# Rezoning Transportation Analysis

Petition Number: 2018-049

**Revision Log:**

Date	Description
05-24-18	First Review
06-14-18	Second Review
08-17-18	Third Review

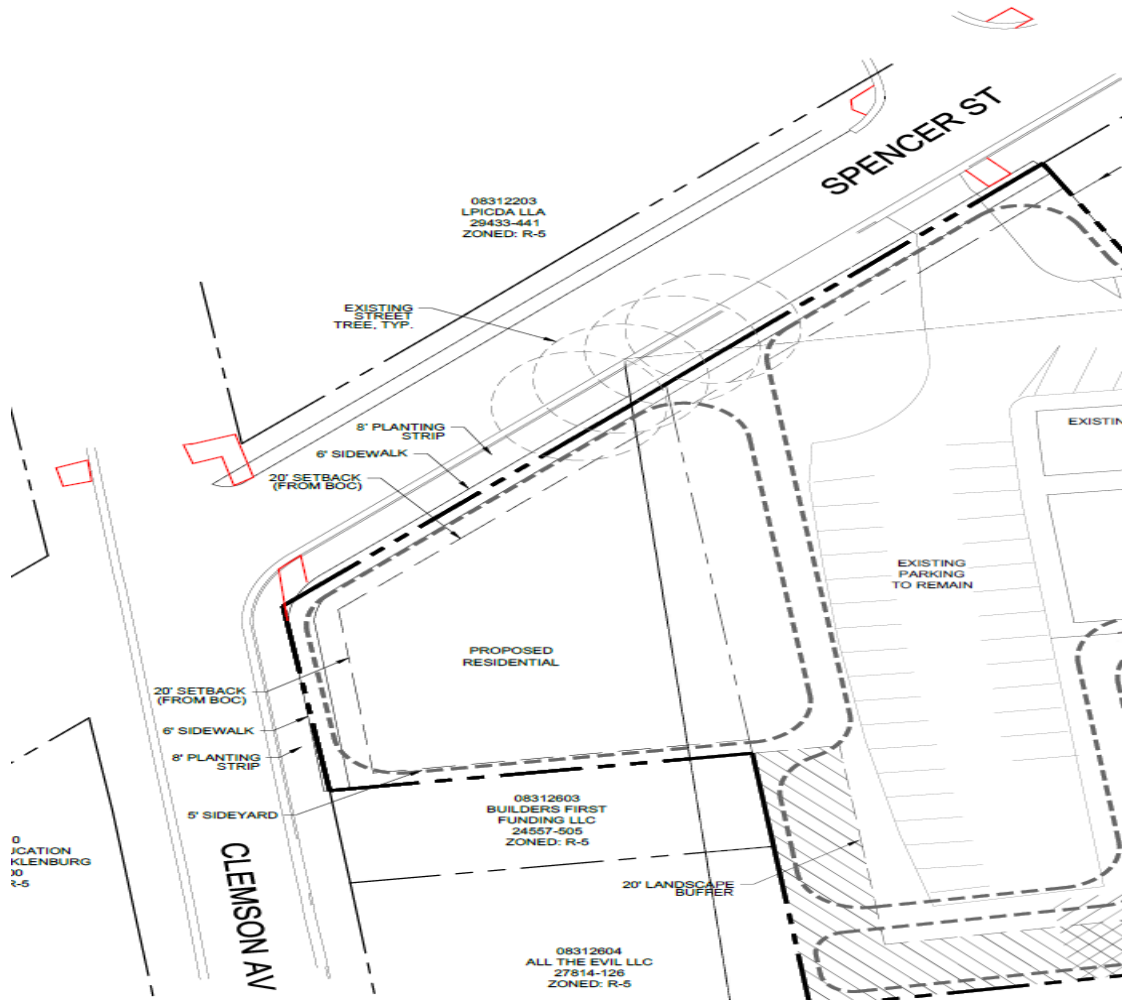
1. ~~**Curbline** The proposed zoning district has a setback measured from back of the existing or proposed future curbline. The existing back-of-curbs are in the correct future location for Charles Avenue, Clemson Avenue, Spencer Street and Whiting Avenue.~~
2. ~~**Traffic Study** A Traffic Impact Study/Transportation Technical Memorandum is not necessary for the complete review of this petition.~~
3. The petitioner should revise the site plan and conditional note(s) to show the proposed sidewalk on Charles Avenue extending to the intersection with Clemson Avenue. This would provide pedestrian access from the proposed development to the Clemson Avenue Park.
4. The petitioner should revise the site plan and conditional notes to show curb ramps at the intersection of Spencer Street and Clemson Avenue and the intersection of East 34<sup>th</sup> Street and Spencer Street as shown below:
